## DEALER RECALL NOTICE LETTER

**Date:** October 8, 2014  
**Subject:** THERMO KING VOLUNTARY SAFETY RECALL  
National Highway Traffic Safety Administration (“NHTSA”) Campaign #14E-055

**Date:** October 8, 2014  
**Subject:** Power Inverter Replacement After Installation – Safety Recall Campaign #14E-055  
**Bulletin Location:** TSA Info Central\Bulletins\Campaign Bulletins

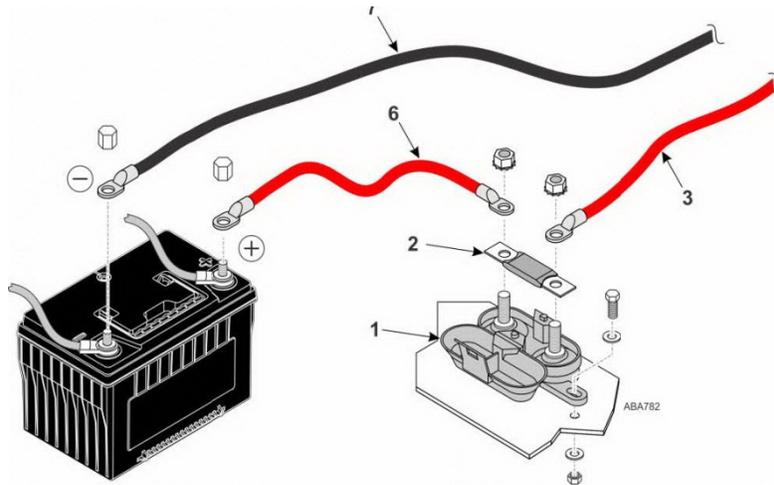
**Description:** TriPac EVOLUTION units built between May 15, 2014 and August 1, 2014 with the Thermo King 1100/1500/2000 Watt Power Inverter installation complete. Do not deliver these units to the customer. Before delivery replace with Thermo King 1000/1800 Watt Power Inverters. If the units have been delivered to the customer these trucks should be located and scheduled into a Thermo King dealer for replacement of the Thermo King 1100/1500/2000 Watt Power Inverter.

Removed Power Inverter	Replacement Power Inverter
1100 Watt 45-2560 (Found in option kit: 073038)	1000 Watt 04-7286
1500 Watt 45-2561 (Found in option kit: 073049)	1800 Watt 04-7285
2000 Watt 45-2562 (Found in option kit: 073050)	1800 Watt 04-7285

1. Locate fuse holder (#1) for the Power Inverter in the truck battery box.
2. Open fuse holder cover.
3. Verify fuse (#2) has been removed.
4. If the fuse has not been removed proceed to Remove Main Power Fuse.

1. Locate fuse holder (#1) in the truck battery box.
2. Open fuse holder cover.
3. Using a 1/2" wrench, remove the nuts that secure the power cables.
4. Remove both power cables from the studs.
5. Insert the fuse (#2) provided with the power inverter (1000W = 150A, 1800W = 250A).
6. Reinstall the power cables on the studs.
7. Install the nuts to secure the power cables and torque to 120 in-lbs.
8. Close fuse holder cover.
